ITEM NUMBER	6.1
SUBJECT	Pre-Gateway: Planning Proposal for land at 355 and 375 Church St, Parramatta
REFERENCE	RZ/10/2018 - D07161401
REPORT OF	Acting Team Leader Land Use Planning
APPLICANT	Stockland Development Pty Ltd
LANDOWNER	McDonald's Australia Ltd

PURPOSE

The purpose of this report is to seek the Local Planning Panel's advice to Council on a Planning Proposal for land at 355 and 375 Church Street, Parramatta. This report recommends forwarding the Planning Proposal to the Department of Planning, Industry and Environment (DPIE) with a request for a Gateway Determination.

Figure 3: Prince Alfred Square SAP and resulting building envelope on subject site
Source: Applicant's reference design

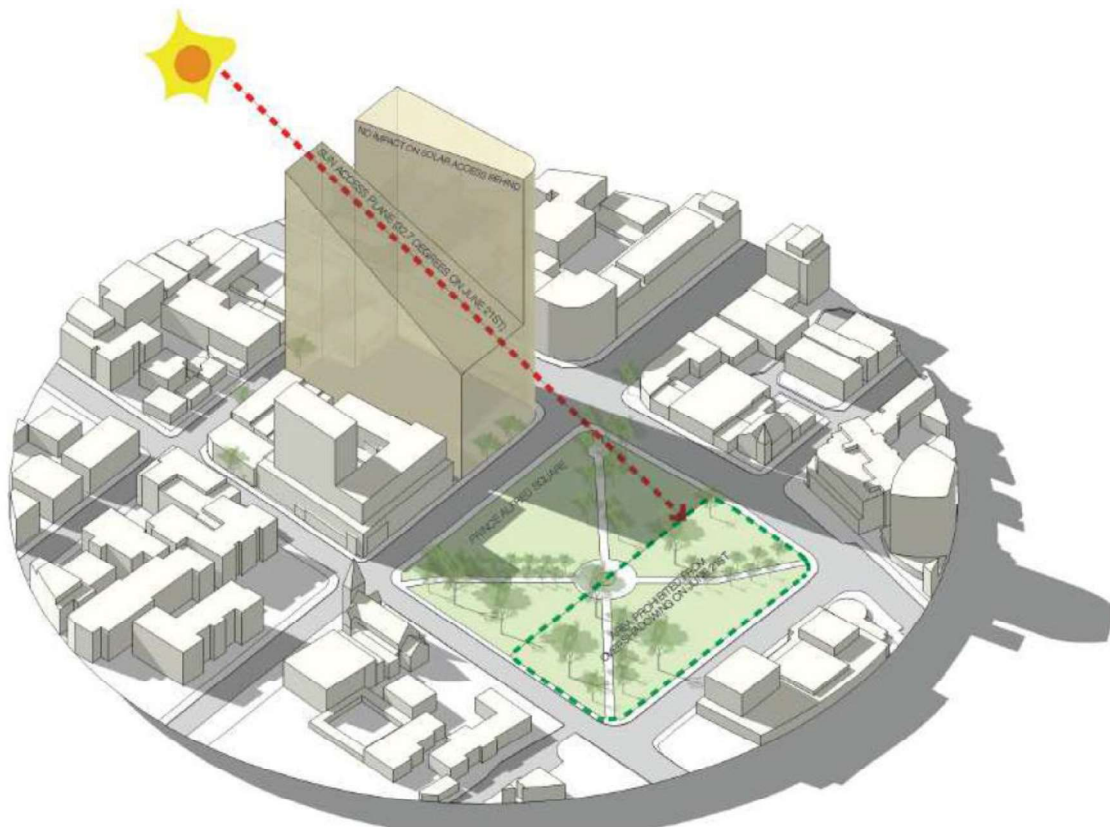
14. The Planning Proposal aligns with the desired outcomes of the Parramatta CBD Planning Proposal on this issue, as it seeks to replicate the Prince Alfred Square SAP in its provisions and presents a preferred scheme that is compliant with this SAP (as discussed in the following section). Therefore, Council officers support the changes to height controls sought under this Planning Proposal.

Figure 4: Example view - Two-tower reference design scheme –outlined in red
Source: Applicant’s reference design with annotations by Council officers

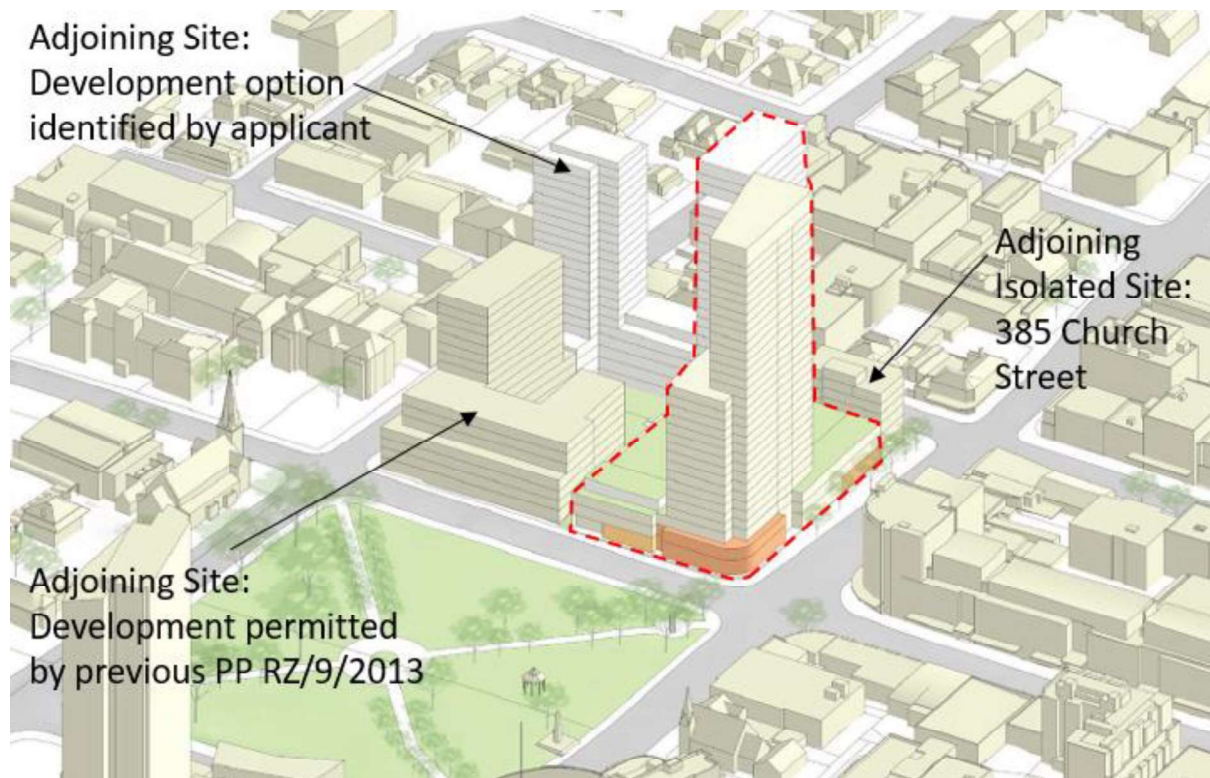
17. The two-tower scheme (shown in **Figure 4**) has a 3-4 storey podium and two offset towers of 28-32 storeys. This scheme does have some non-compliances with separation requirements set out in the *Apartment Design Guide* (ADG), as well as upper-level (i.e. tower) setback requirements set out in the *Parramatta Development Control Plan (DCP) 2011*. These non-compliances include:

- a. Tower setback of 3m along Church St (the DCP specifies 4m);
 - b. Building separation between the upper levels of the two towers is 9-12m, which is less than that specified in the ADG (12-24m); and

- c. Building separation between Ross Street tower and potential development at 383 Church St (discussed in further detail in a later section of this report).

18. Despite these non-compliances, Council officers consider that the scale of the towers and podium in the two-tower scheme is more sensitive to the local context, which includes Church Street, Heritage-listed Prince Alfred Square, and other nearby Heritage items. Council officers consider that the scale of the podium of the two-tower scheme is more appropriately matched with that of nearby buildings, and that dividing the mass between two towers creates a more appropriate relationship between towers on this site and other likely future development in the vicinity (as envisioned under the Parramatta CBD Planning Proposal). To illustrate this point, **Figure 6** illustrates the massing of the preferred two-tower scheme within the outline (blue dashed line) of the massing of the one-tower scheme.

19. In conclusion, Council officers support progressing a two-tower scheme as the preferred reference design for this site based on the analysis above. It is recommended that an important focus for the Design Competition and Development Control Plan (DCP) processes for this site will be to minimise any non-compliances of a two-tower scheme.

Figure 5: Example view - one-tower reference design scheme (outlined in red)
Source: Applicant’s reference design with annotations by Council officers

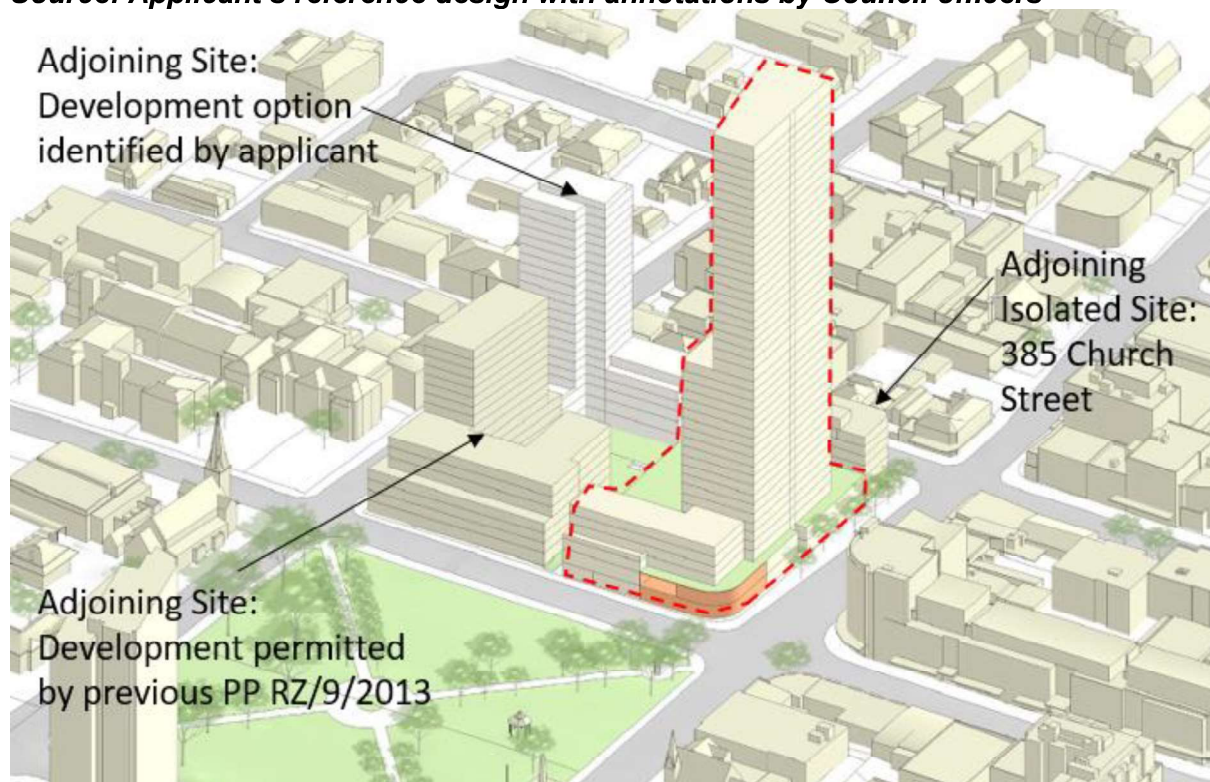
16. The one-tower scheme (shown in **Figure 5**) has a 7-8 storey podium and a single tall tower of 48 storeys fronting Church Street. The Prince Alfred Square SAP is the main driver behind the form of this scheme. The SAP impacts development massing on this site by push the massing “down” into a higher podium and “out” to the eastern part of the site to become concentrated into a single tall tower located on the Church St frontage.

Figure 7: Extract of Council's Heritage Map - subject site in blue
Source: Parramatta LEP 2011 (with added annotation for subject site)

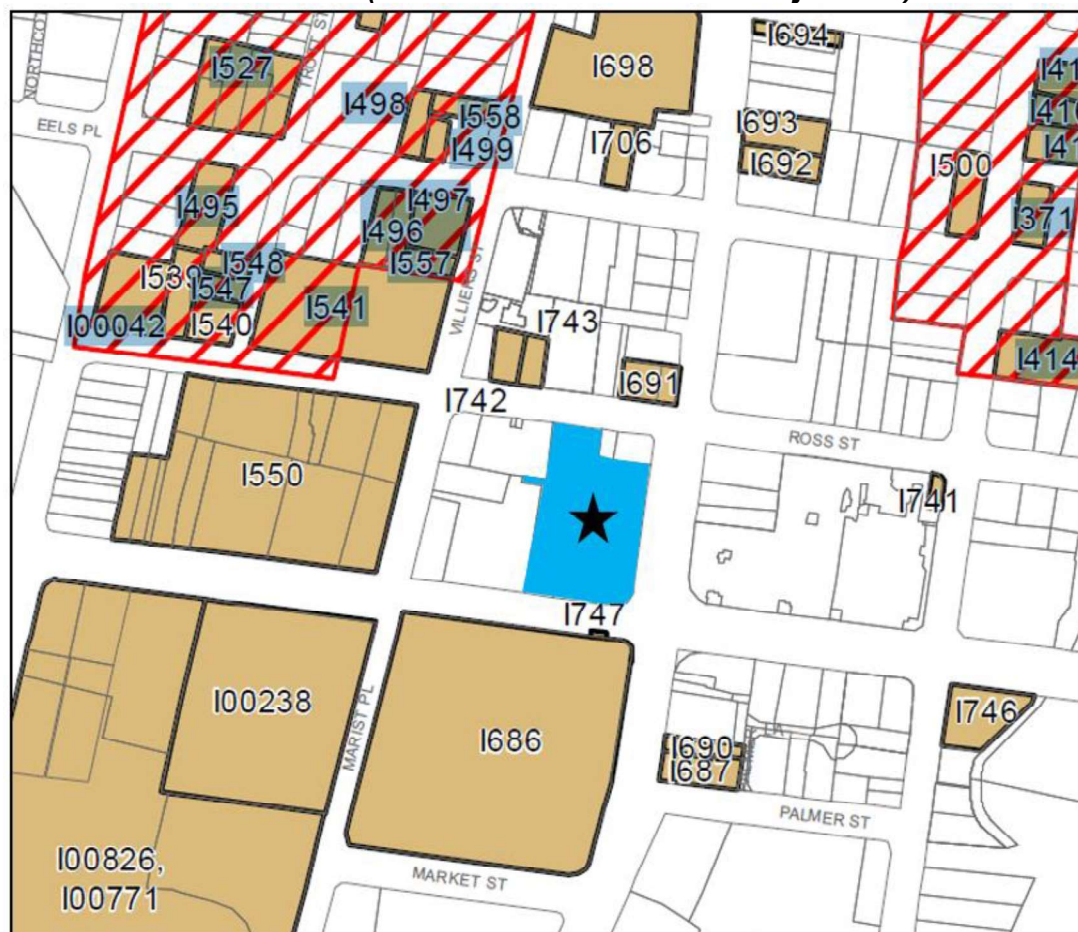
22. Council's heritage officer has reviewed the proposal and requested that the proposal be consistent with the Parramatta CBD Planning Proposal. Given the proximity to Prince Alfred Square (a State-listed item), Council's heritage officer also recommended that preliminary consultation be undertaken with the Office of Environment and Heritage (OEH).
